SECTION 00 91 13.1 – ADDENDUM 1

- A. Project Name: Lincoln Quad Demolition and Site Restoration.
- B. Owner: Indiana State University.
- C. Owner Project Number: B0027341.
- D. Architect: arcDESIGN, PC.
- E. Architect Project Number: 19189.
- F. Date of Addendum: Monday, October 5, 2020

DRAWING NUMBER
C110

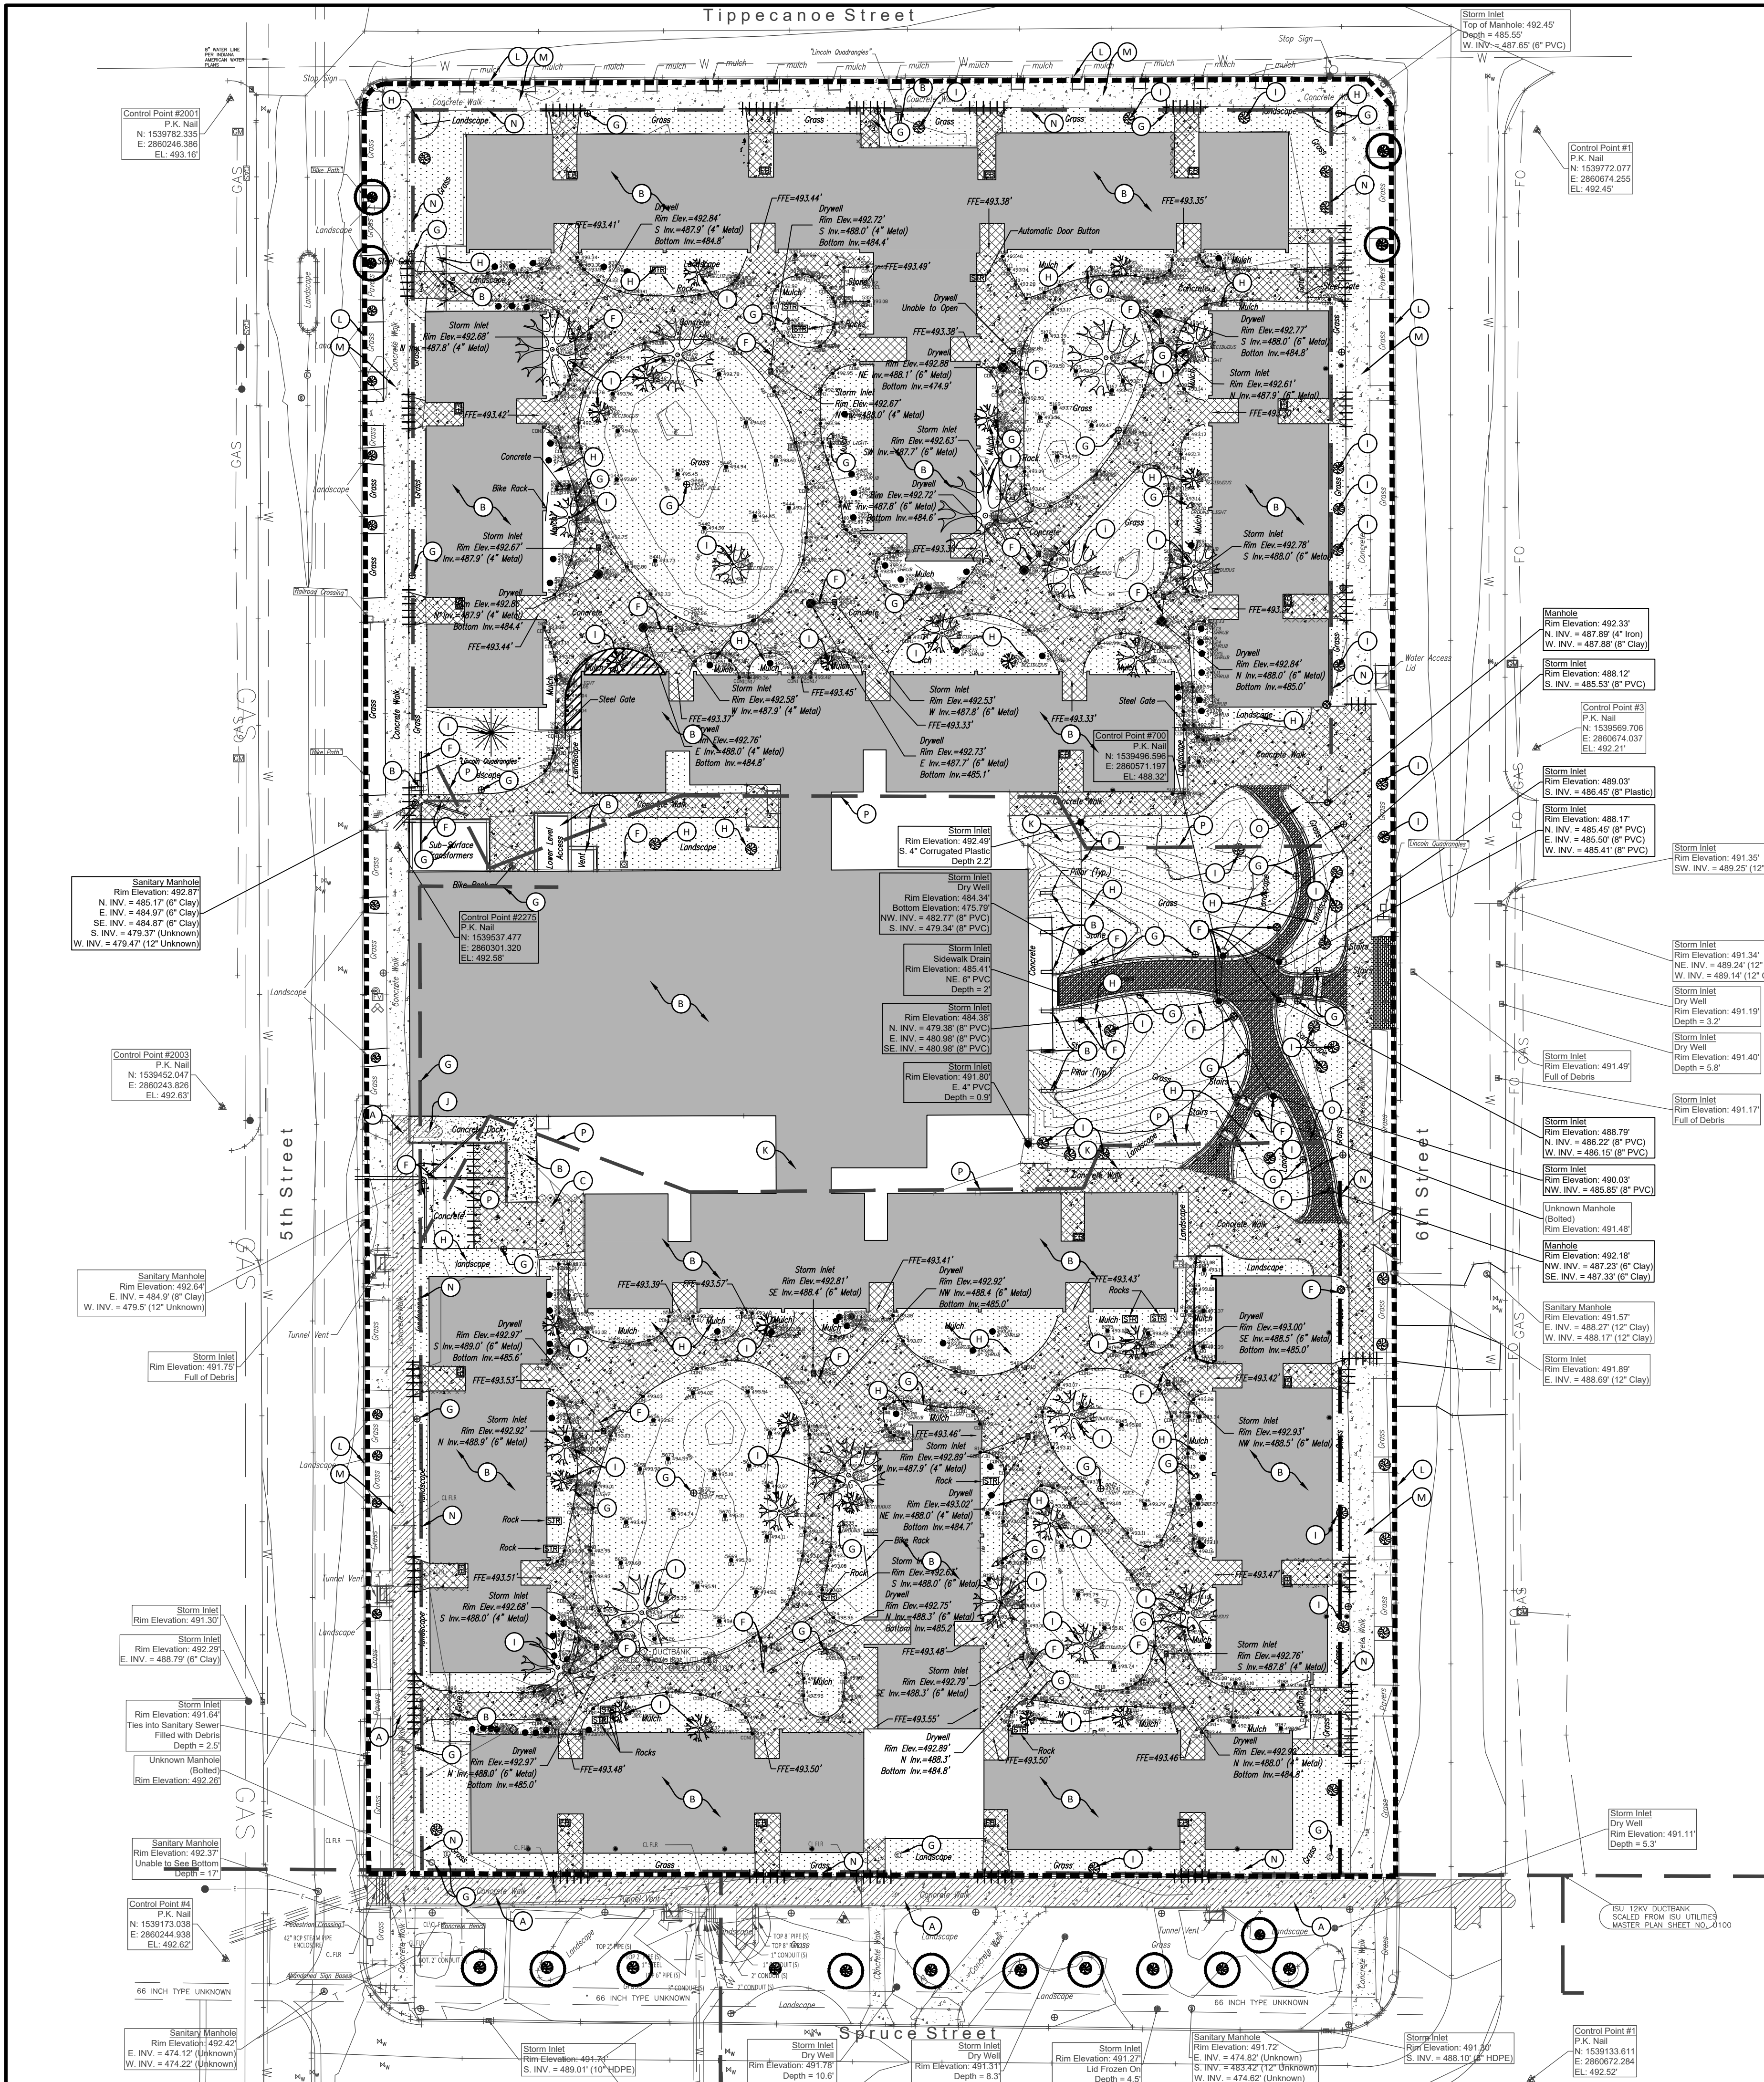
- TRANSITE IN DUCTBANK AND UTILITIES BELOW ARE TO BE ABANDONED IN PLACE. COORDINATE WITH ED100 & MD100.
- ELECTRICAL PULL HOLE TO BE REMOVED. COORDINATE WITH ED100

- TRANSITE IN DUCTBANK TO BE REMOVED. COORDINATE WITH ED100 & MD100

SITE AND TUNNEL DEMOLITION - MECHANICAL AND PLUMBING

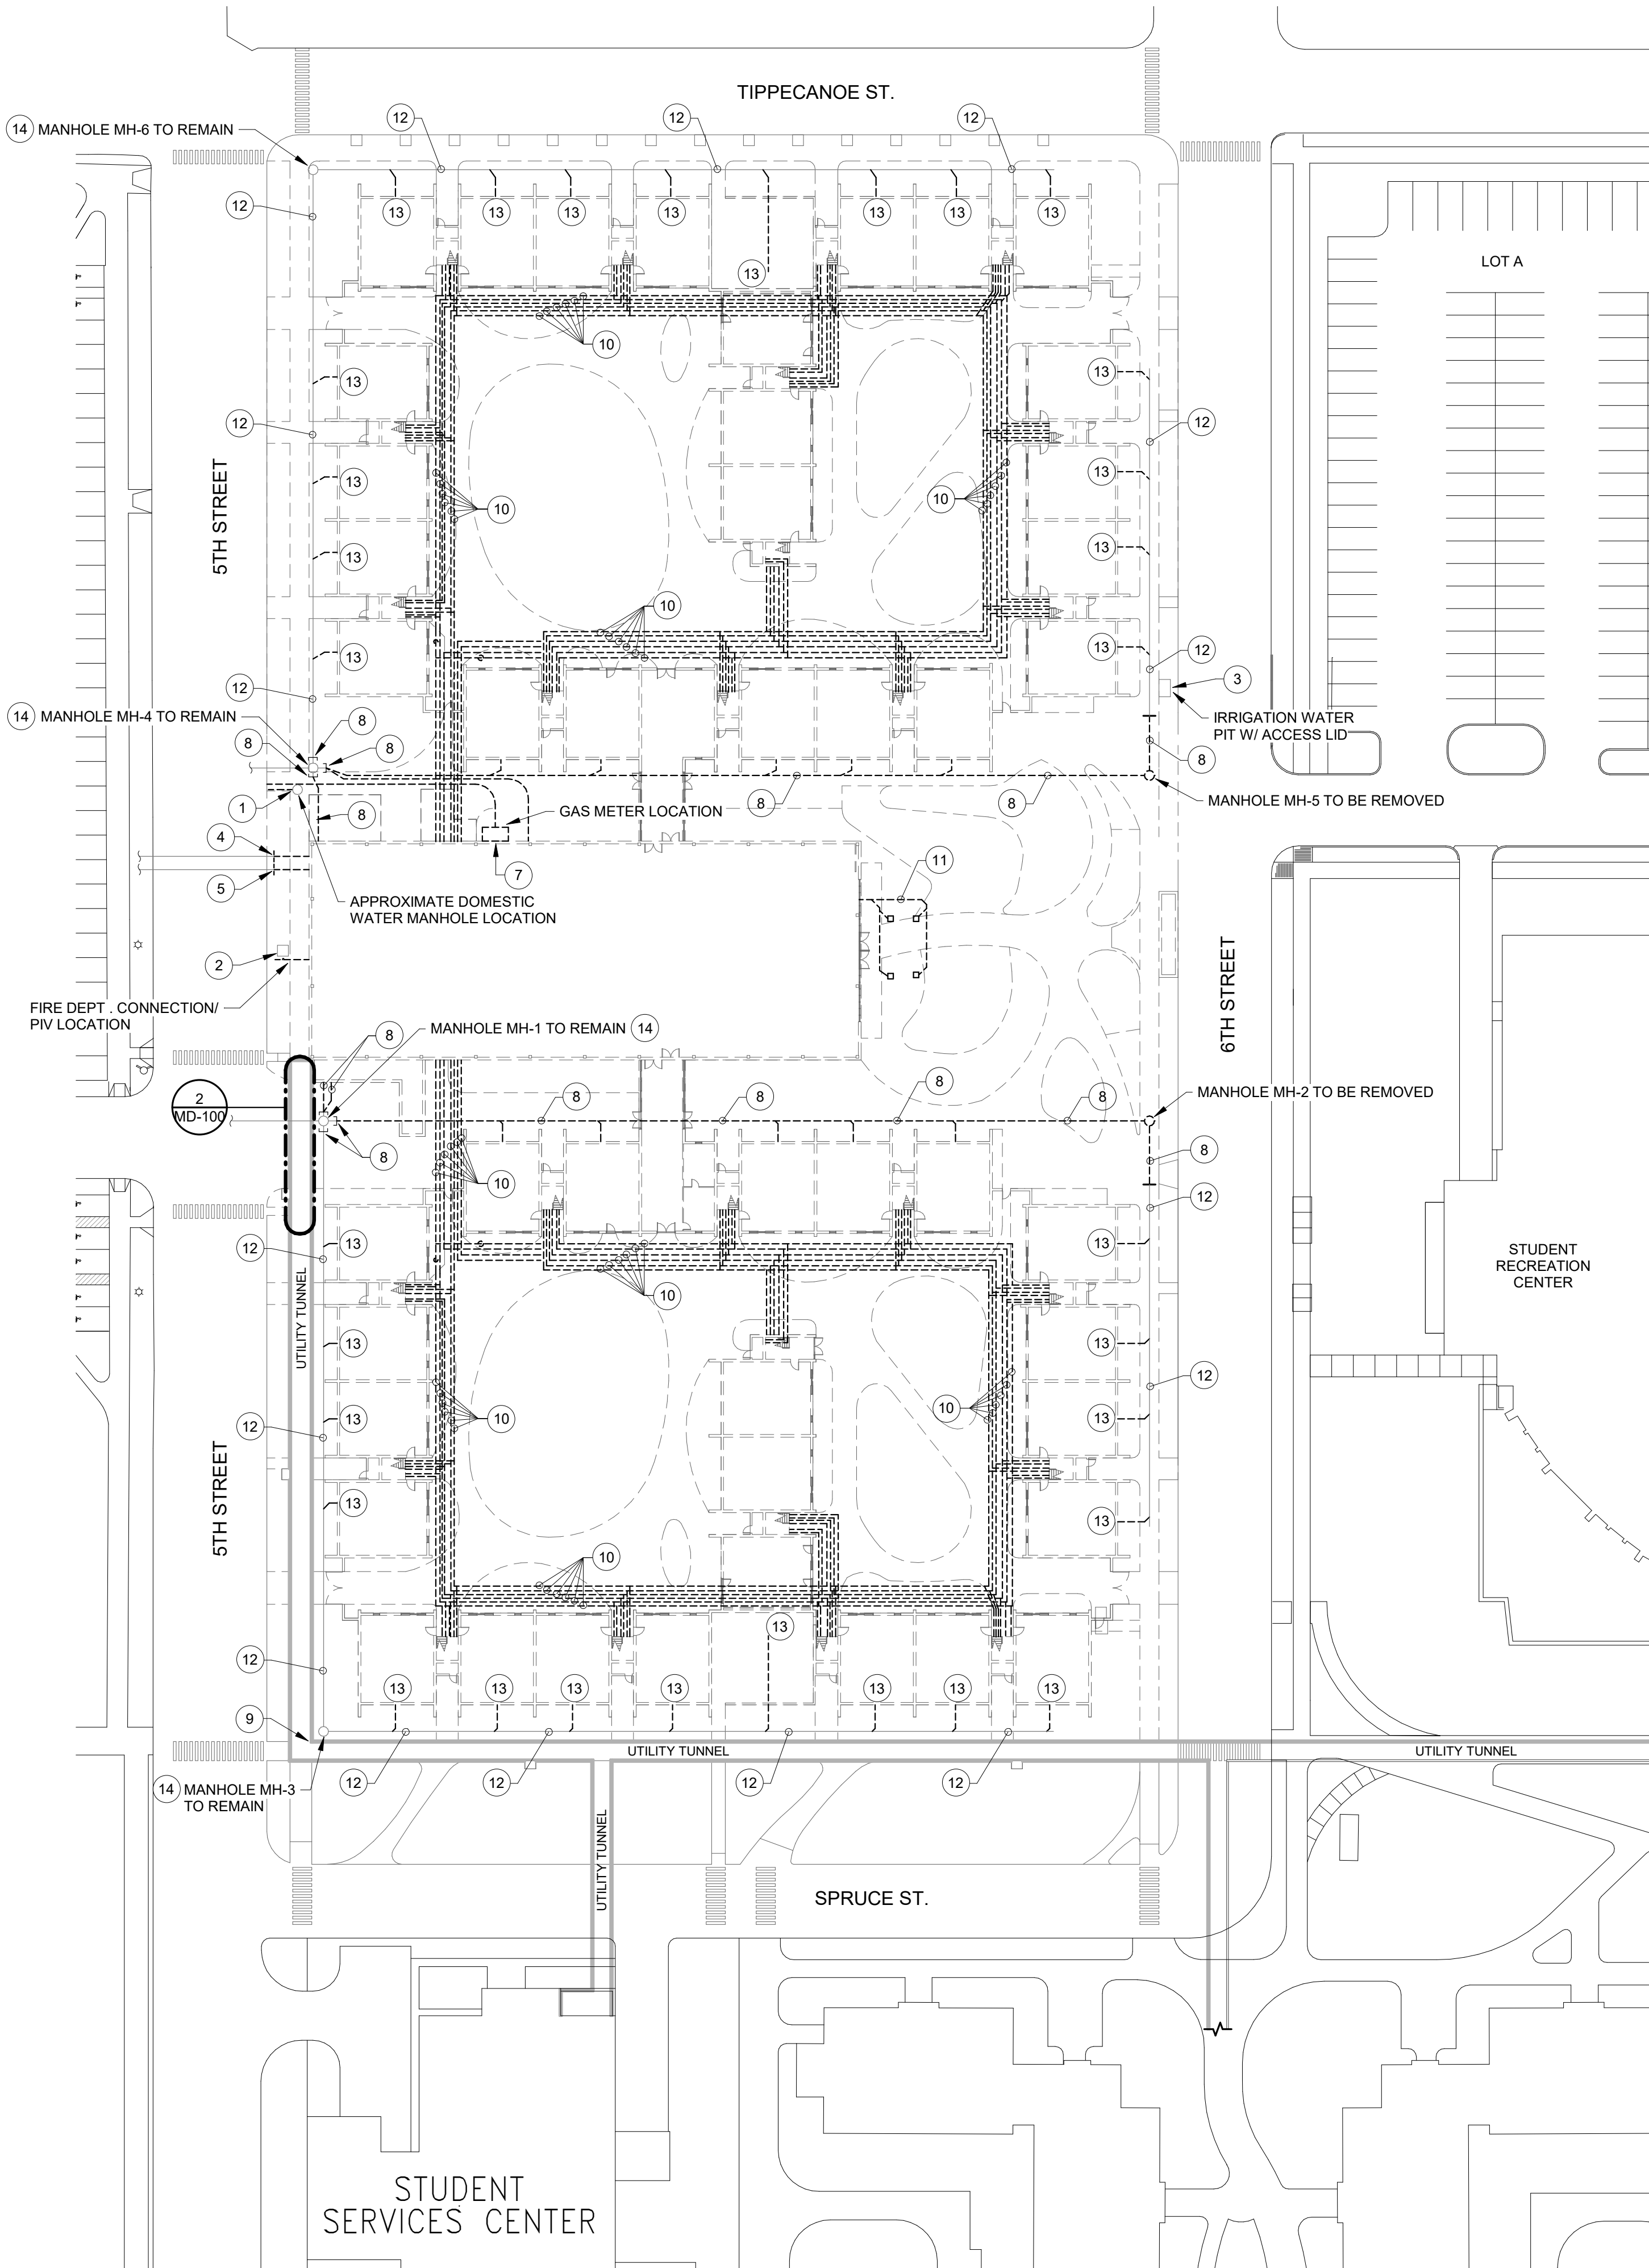
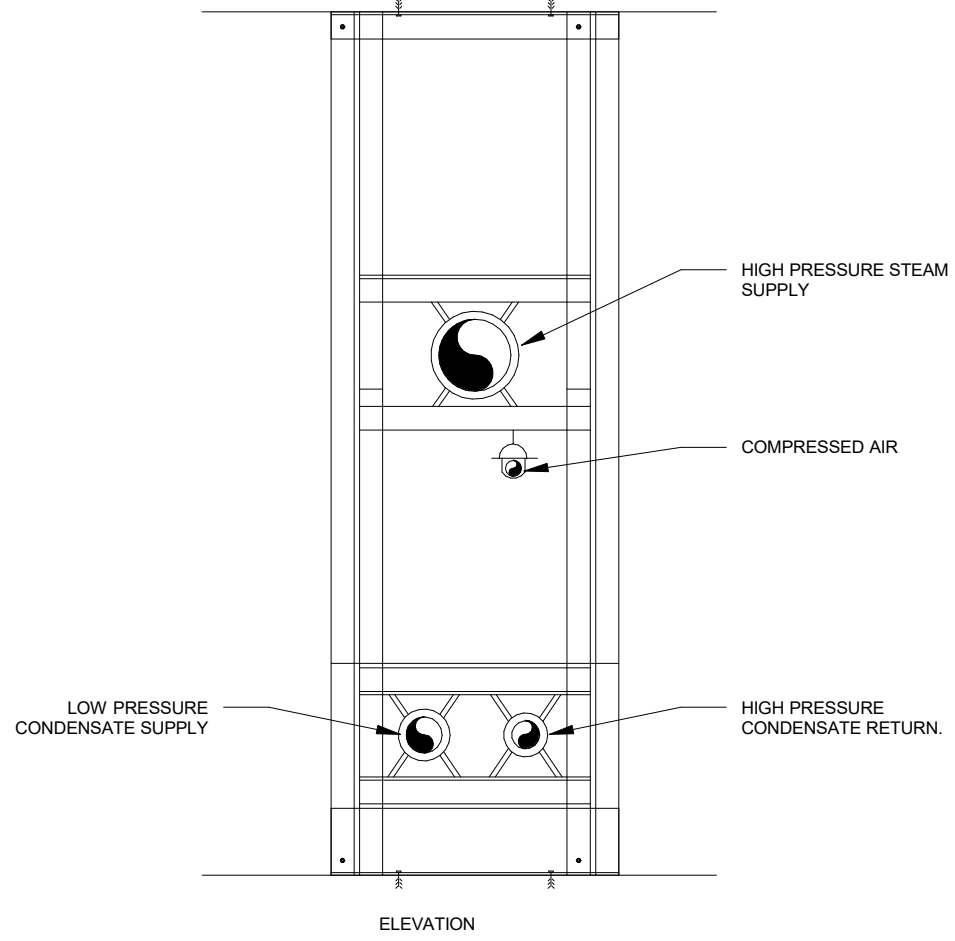
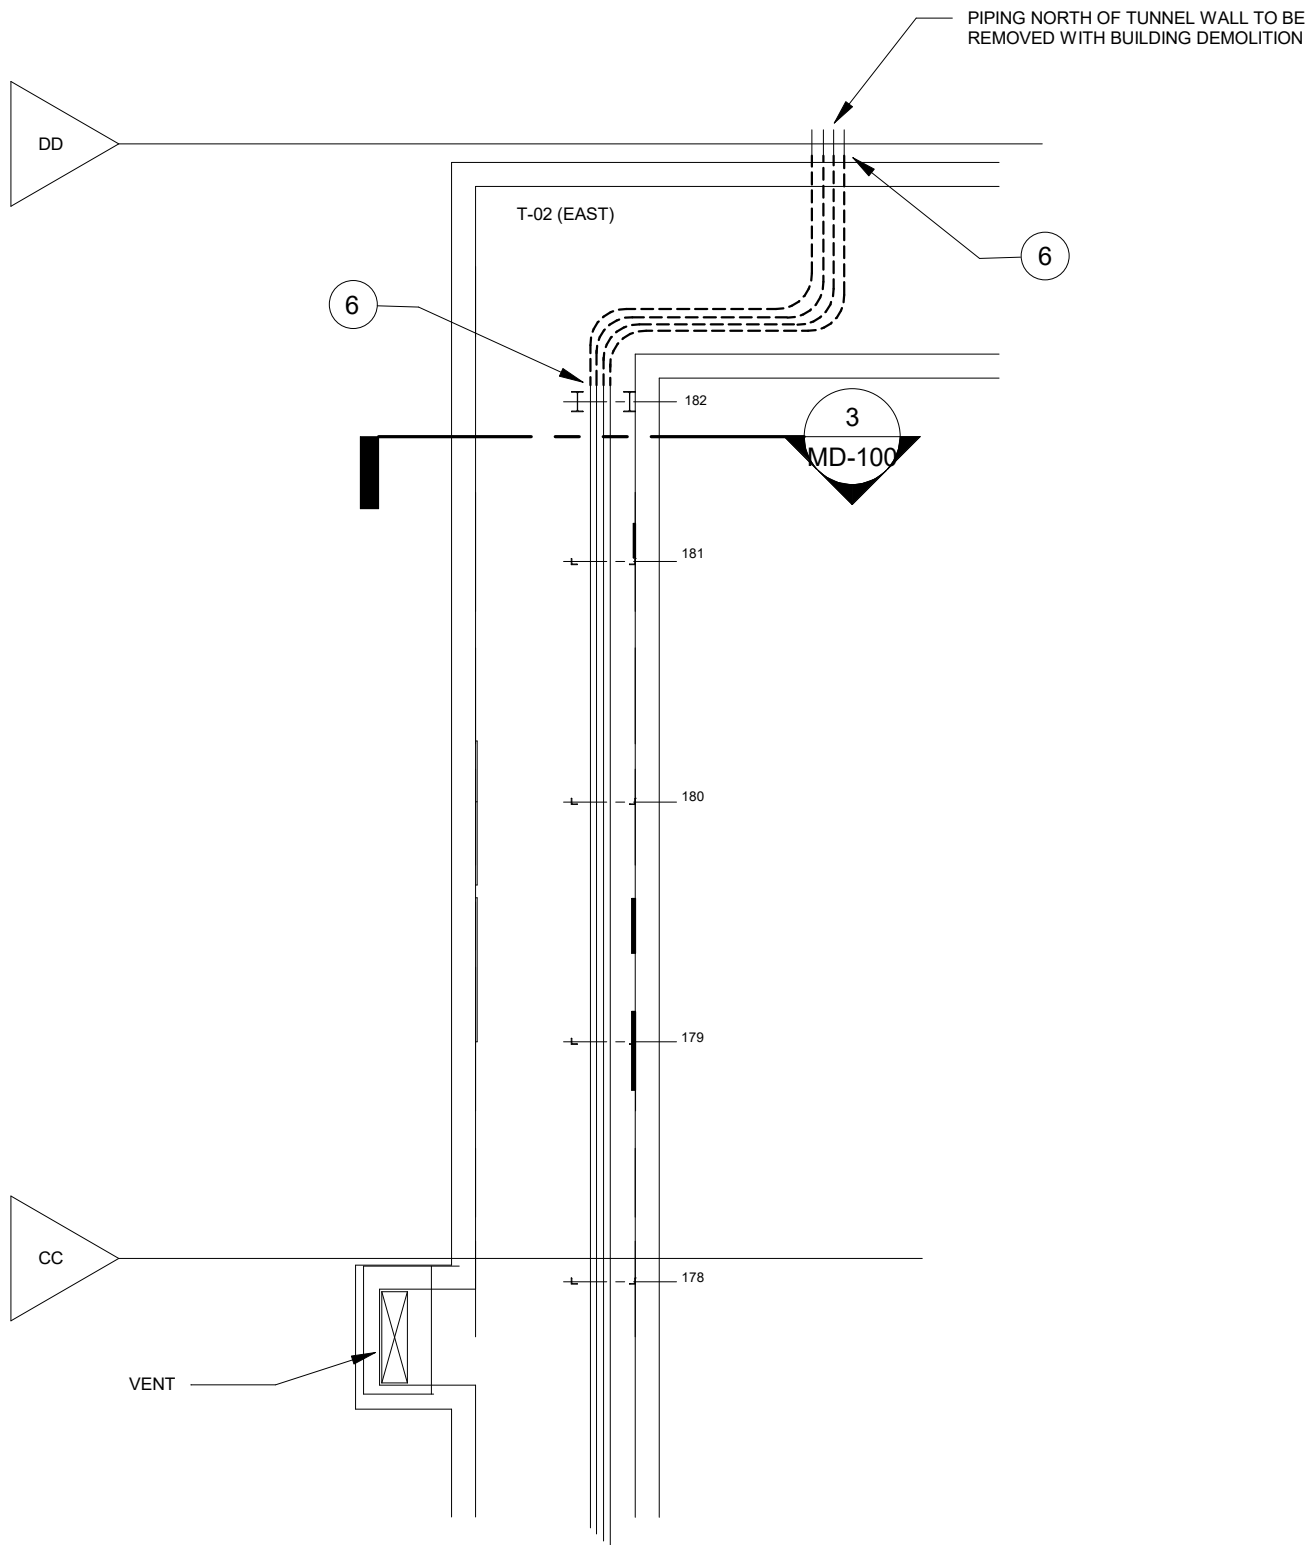
- EXISTING 6" VT SEWER LINE TO REMAIN AND BE ABANDONED IN PLACE. CAP/SEAL ALL ENDS, INLETS, BRANCHES, ETC.
- REMOVE 4" VT LATERAL FROM BUILDING OUT TO 6" PERIMETER MAIN LINE WHICH IS TO BE ABANDONED IN PLACE PER PLAN NOTE 12. REMOVE DOUBLE YARD CLEANOUT WITH THIS LATERAL. REFER TO DETAIL ON ORIGINAL DRAWING 63. CAP AND SEAL EXISTING PIPE.
